NAME	DATE	MASSACHUSETTS INSTITUTE OF TECHNOLOGY
Drawn:	RFGoeke	5/2/95	CENTER FOR SPACE RESEARCH
Checked:	DGordon	5/3/95	
Approved:	RFGoeke	5/3/95	**ACIS Input to RCTU**
Released:	DGage	5/3/95	**Interface Requirements**

ACIS Input to
RCTU Interface Requirements

36-02206

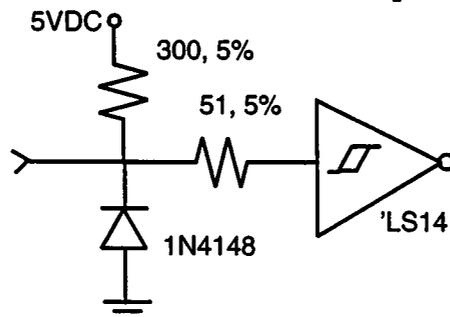
The circuit shown is inconsistent with the various specifications. In particular, one can just drive the 1300pf capacitive load with 300 ohms and meet the rise time requirements (which probably should be 400 ns, as in the case of the Serial Telemetry Interface); no room for component tolerance is allowed. Further, the drive transistors have specified saturation characteristics only under a 1 ma load (far less than that provided by the 300 ohms). The maximum current load allowed is 15.3 ma, which will be exceeded under conditions of high bus voltage and a low-tolerance pull-up resistor.

It has been our experience that a Schottky-barrier diode has virtually no immunity to transients which exceed DC current ratings. A 35 milliamp diode at DC is a 35 milliamp diode to a 1 μs pulse. The failure mode is a short. As a clamp, therefore, to guard against ringing and EMI-generated noise spikes, the choice of a 1N5711-series part seems inappropriate.

We are using a 300 ohm pullup resistor on these lines, but with the caveat that the driver must be capable of meeting its requirements with a maximum load of 21ma (tolerancing both the 5VDC bus and the resistor). We assume the use of single, RC05 resistors.

We assume that the total load capacitance seen by the driver is required not to exceed 1000pf.

We have substituted a 1N4148-series part for the recommended clamp diode.

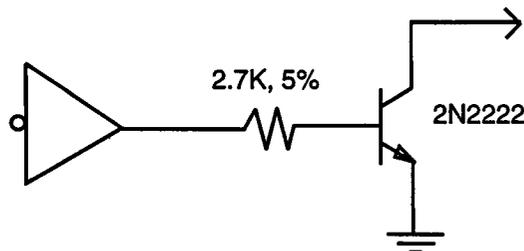
The problems previously stated apply.

The logical sense of the signals may be confusing in relating Table 3-1 and Figure 3-8 of the TRW document. *At the interface* the enable and clock are active low and the data is active high. This is only a problem in that it conflicts logically with the sense of the command interface where, in that case, the data is active low.

We have eliminated the speed-up capacitor, diode, and base-emitter resistor in the transistor drive circuit as unnecessary. We have decreased the base drive somewhat so that the forced B does not exceed 10.

We assume that the total load capacitance seen by the driver is required not to exceed 1000pf. We assume that the total load current seen by the driver is not to exceed 21ma.
